MODIFICATION RECOMMENDED

E5070B-12D

N O T E

E5070B RF Network Analyzer, 300kHz to 3 GHz

Figure 1 Make A7 assembly (for option 214 & option314/414 with 1 attenuator)

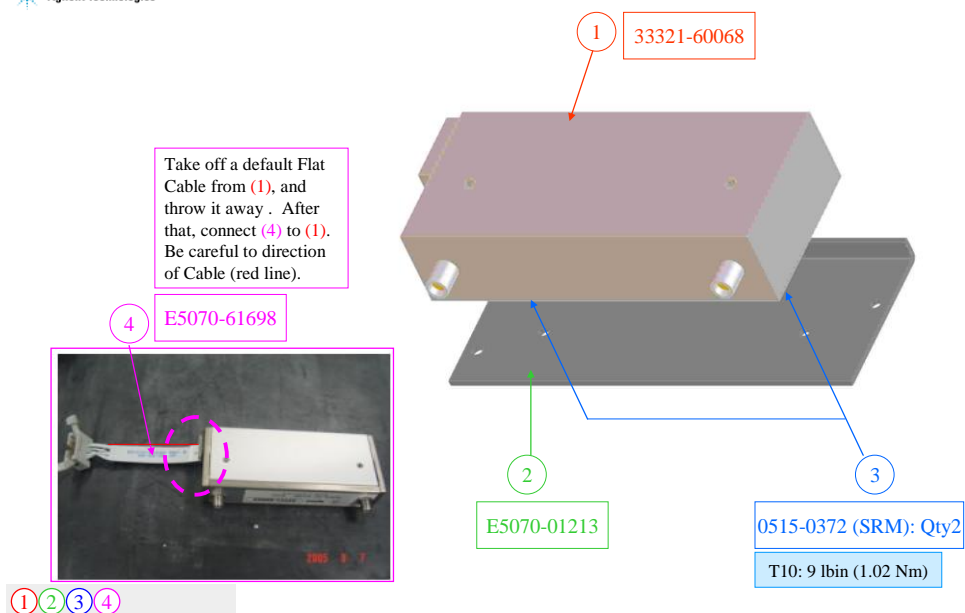
1. Disassemble the product. (Refer to E5070B/E5071B Service manual chapter 6 for details)
2. Make A7 step attenuator assembly by 33321-60068 (1ea), E5070-61698 (1ea), E5070-01213 (1ea), 0515-0372 (2ea) and E5070-61617 (1ea). E5070-61698 is the cable between 33321-60068 and E5070-61617. Scrap 33321-60059.
- 2-1. Scrap the flat cable that comes with the new attenuator (33321-60068).
- 2-2. Connect E5070-61698 to 33321-60068.
- 2-3. Connect E5070-61698 to E5070-61617.

**Figure 2 Install A7 attenuator assembly (1)**

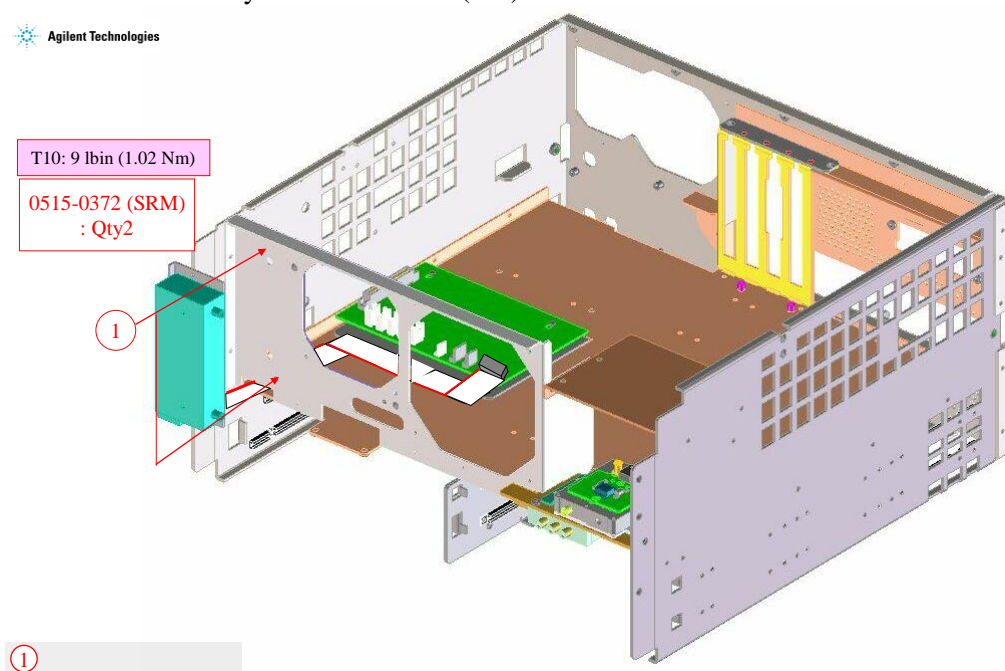
3. Install A7 assembly with 0515-0372 (2ea).

**Figure 3 Install A7 attenuator assembly (2)**

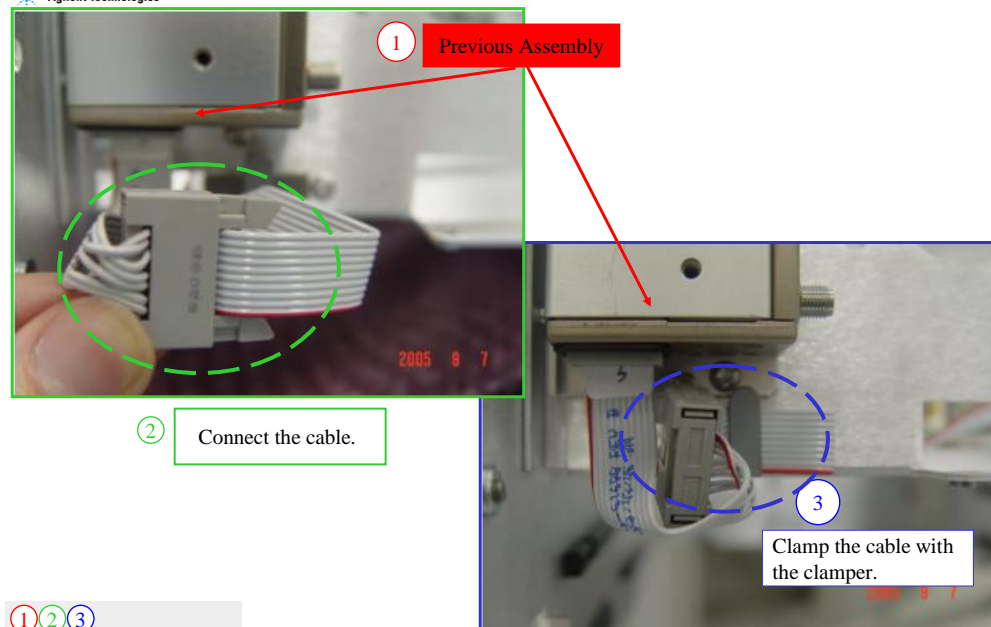
4. Connect the cable and clamp the cable with the clumper. Be careful to flat cable direction and its connectivity.

Figure 4 Make A7 assembly (for option 314/414 with 2 attenuators)

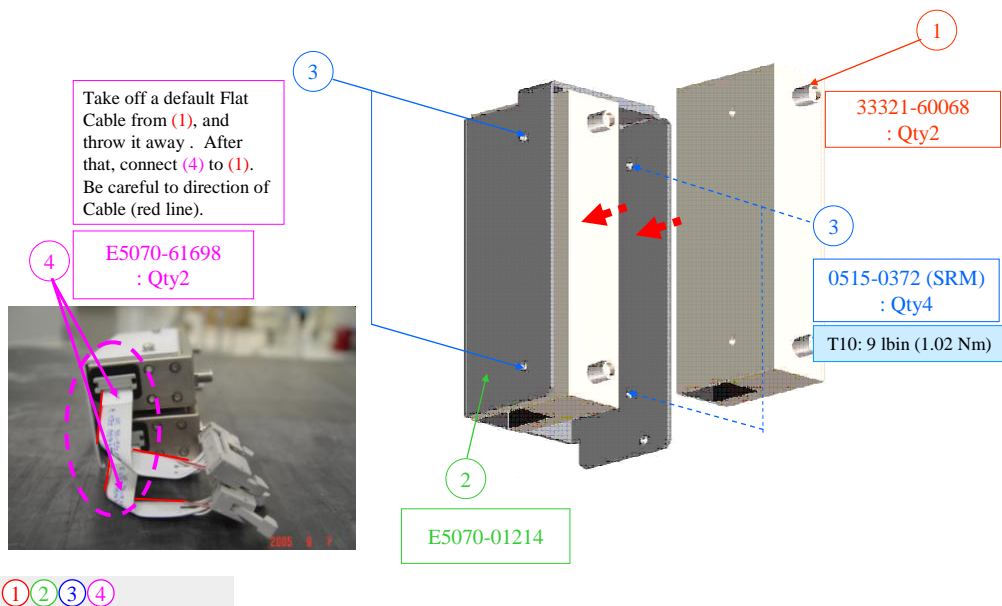
1. Disassemble the product. (Refer to E5070B/E5071B Service manual chapter 6 for details)
2. Make A7 step attenuator assembly by 33321-60068 (2ea), E5070-61698 (2ea), E5070-01214 (1ea), 0515-0372 (4ea) and E5070-61618 (1ea). 2ea of E5070-61698 are the cable between 33321-60068 and E5070-61618. Scrap 33321-60059.
- 2-1. Scrap the flat cable that comes with the new attenuator (33321-60068).
- 2-2. Connect E5070-61698 to 33321-60068. (This is done twice)
- 2-3. Connect E5070-61698 to E5070-61618.

**Figure 5 Install A7 attenuator assembly (1)**

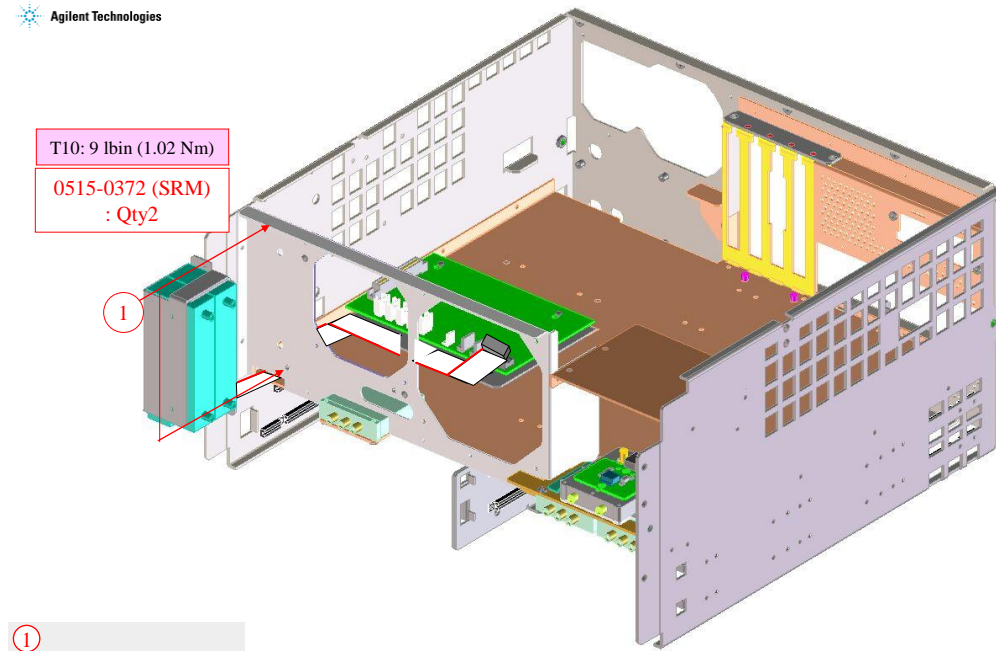
3. Install A7 assembly with 0515-0372 (2ea).

**Figure 6 Install A7 attenuator assembly (2)**

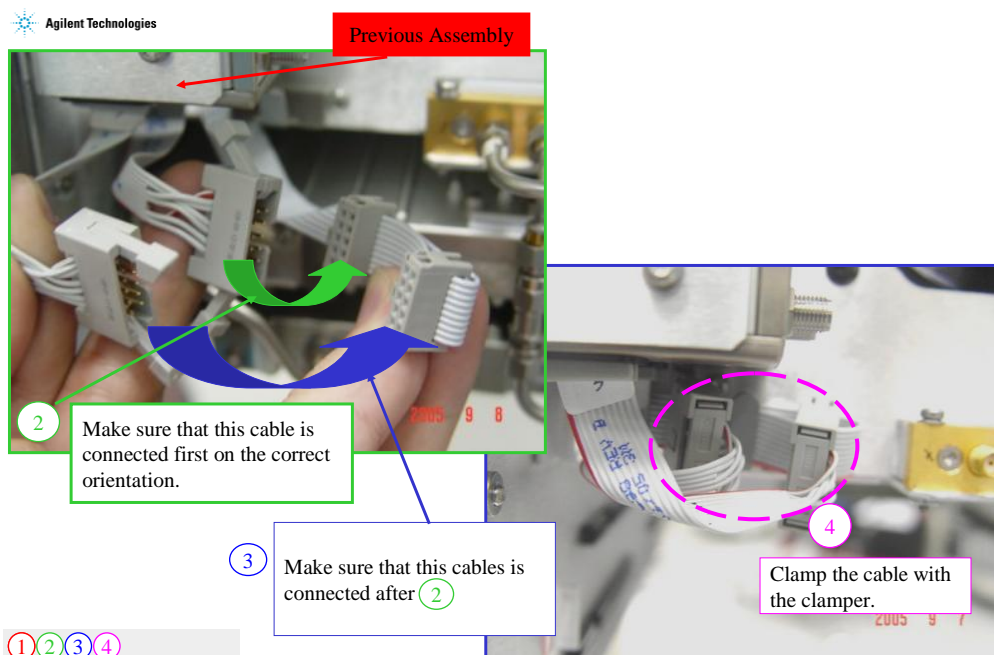
4. Connect the cable and clamp the cable with the clamber. Be careful to flat cable direction and its connectivity.
